# ADDENDUM NO. 1

**TO:** All Plan Holders  
**FROM:** Studio Kremer Architects  
**DATE:** September 23, 2020  
**PROJECT:** **OVEC office interior renovation and storage addition**  
ska# 2019-51

title / description: <b>Built-in Shelving</b>		sketch no.:
project no.:	#	ASK 01
date:	09.23.2020	
drawn by:	JA	
checked by:		
scale:	see drawing	reference dwg:

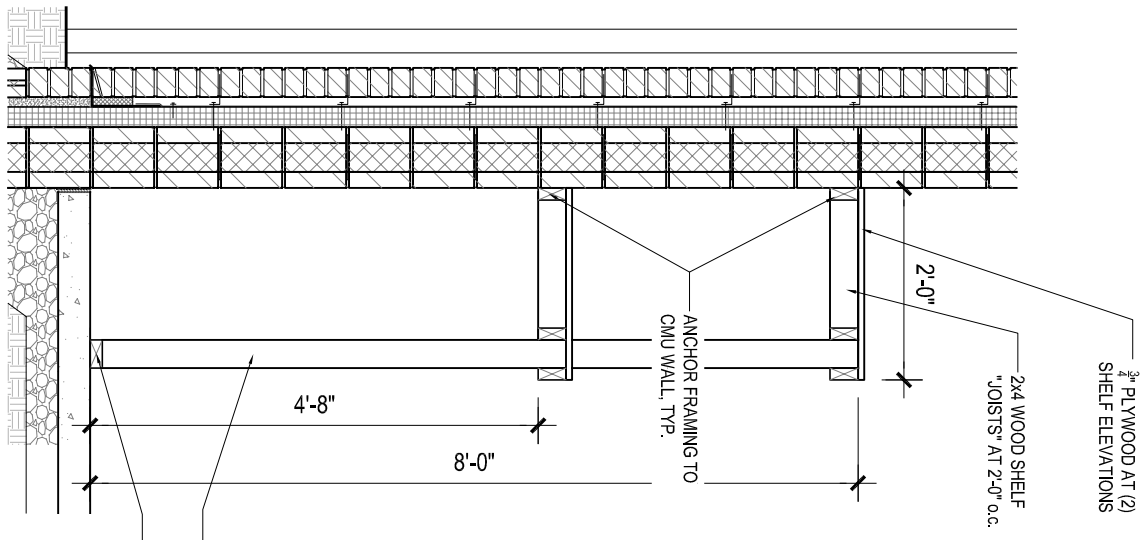
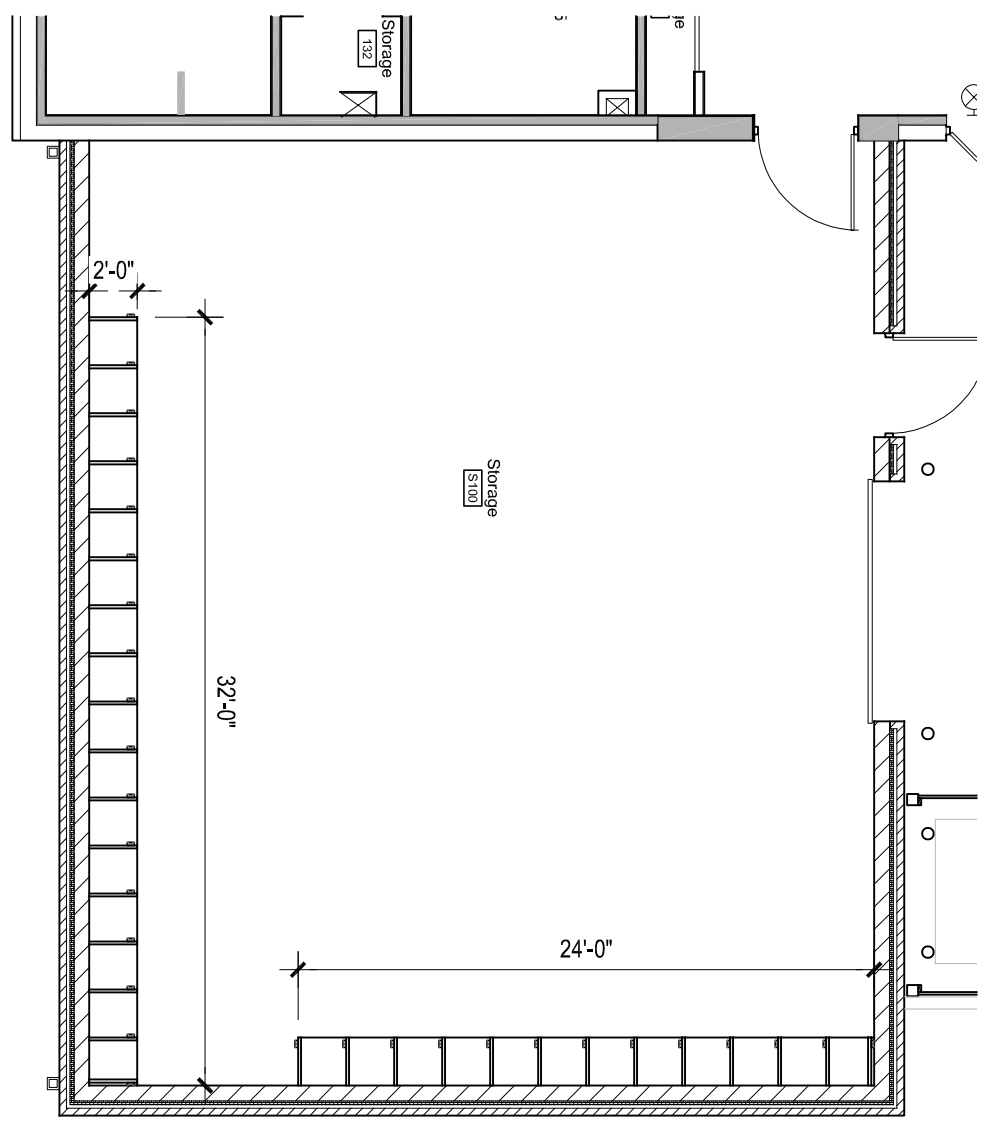
Per attached drawing ASK 01, built-in wood shelving shall be provided in the areas indicated inside the new storage addition. These shall be constructed of wood stud framing and ¾" plywood.
